Project Office, Room 308, Town Hall, MANCHESTER M60 2L1
+44 (0) 7970 097 432
www.purcelluk.com

PROJECT STATUS	RIBA STAGE 5
CLIENT	MANCHESTER CITY COUNCIL
PROJECT	OUR TOWN HALL
DRAWING TITLE	Rooflight WCR01 Proposed Window Component Drawing
SIZE & SCALE	A1: Scale as Stated
DRAWING STATUS	ISSUED FOR CONSTRUCTION
JOB NUMBER	236959
DRAWING NO.	OTH-PUR-TH-RF-DWG-A- 7484
REV	02

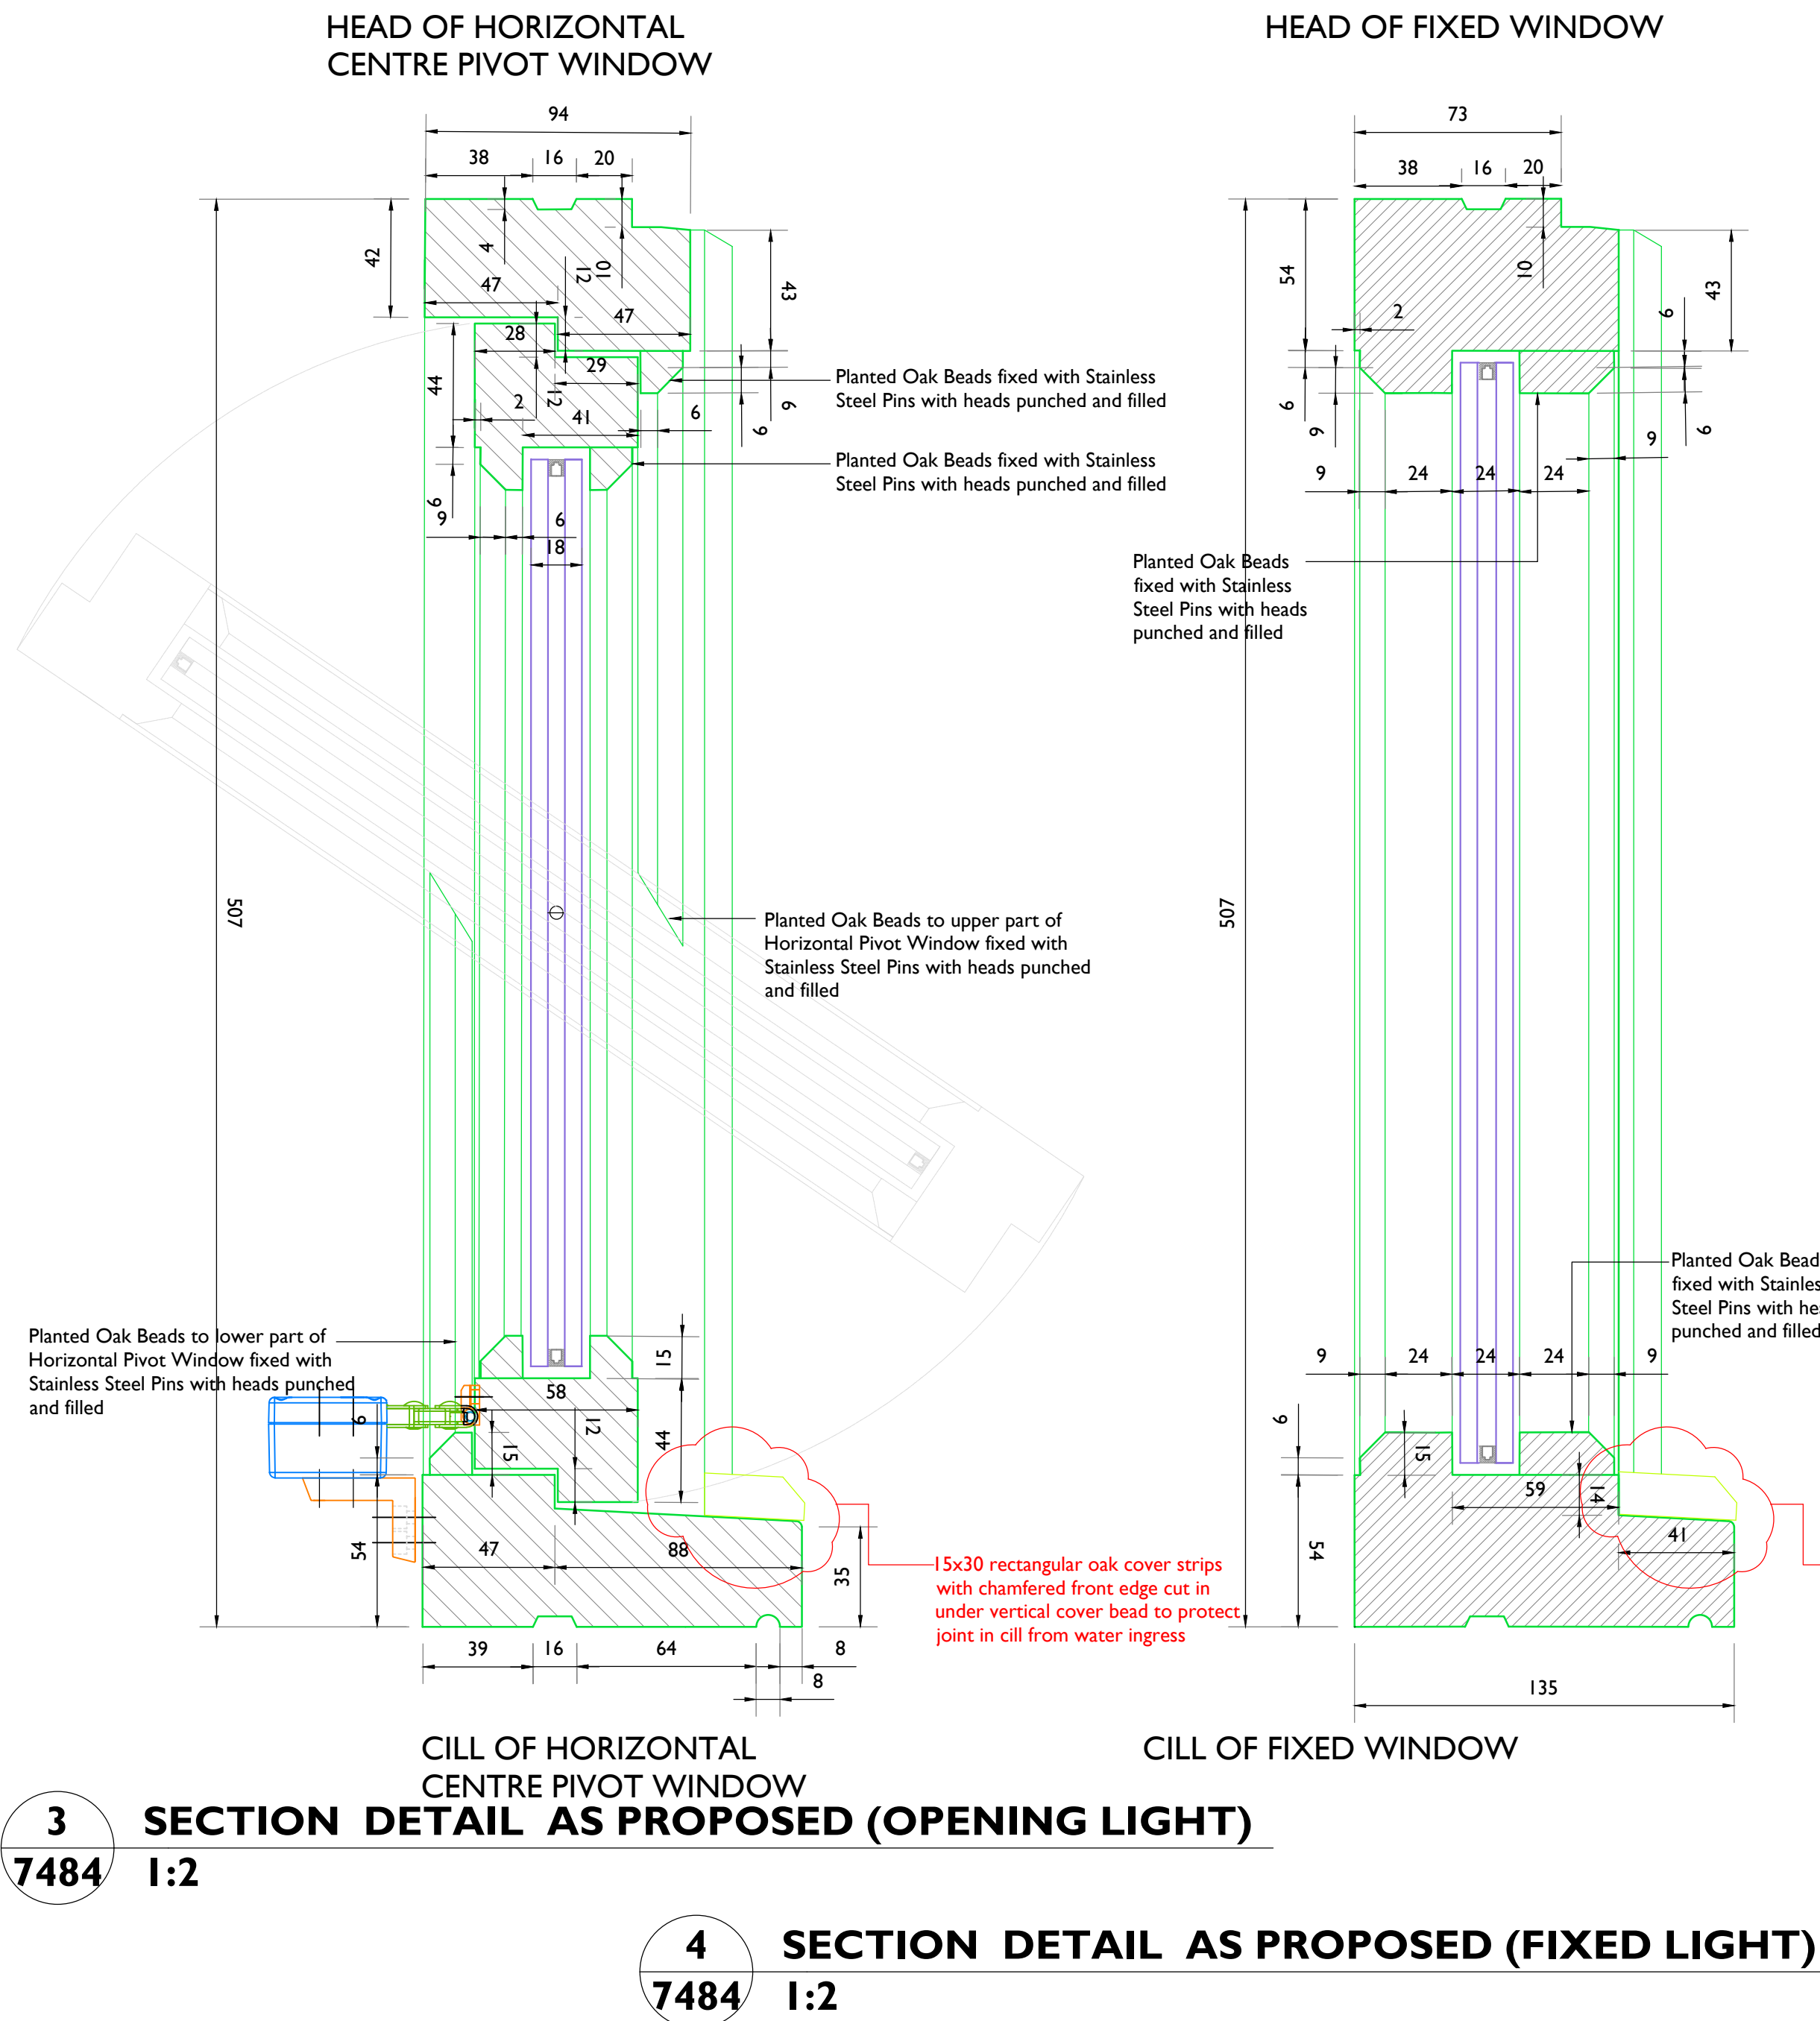
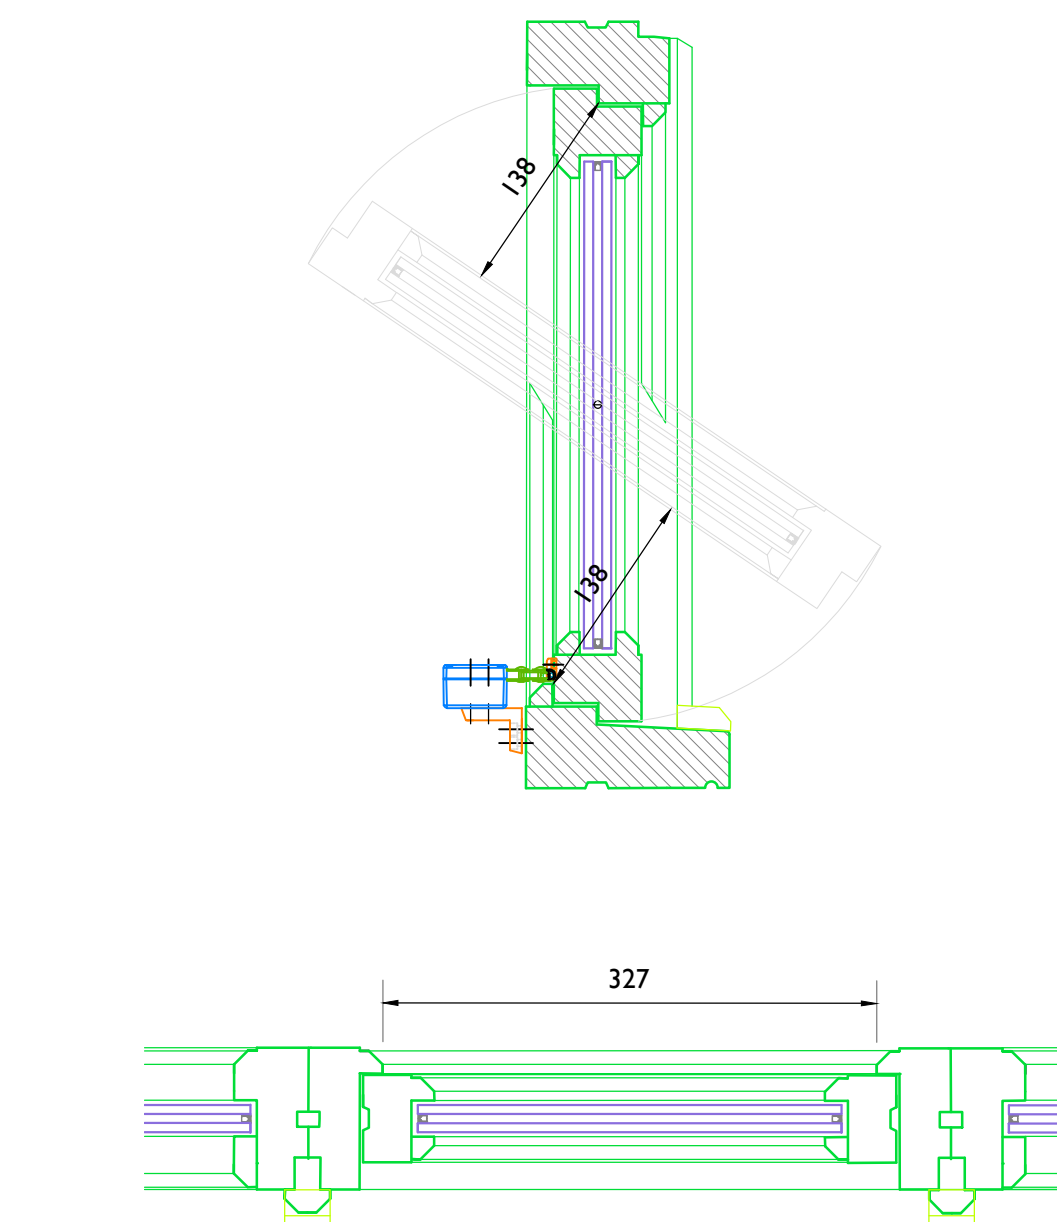
REVISION 02
As oak cill has been formed from multiple sections instead of as continuous cill, oak cover strip installed on top of cill to protect joints from water ingress.
End section of cill to ribbon window to have 45° chamfer

Rev 02	26/06/2024	JC	SE	Oak cover strip added to cill joints cill end chamfered
Rev 01	12/11/2023	JC	SE	Window height shortened and cill projection increased. Free ventilation area added.
	29/08/2023	SE	SE	First Issue
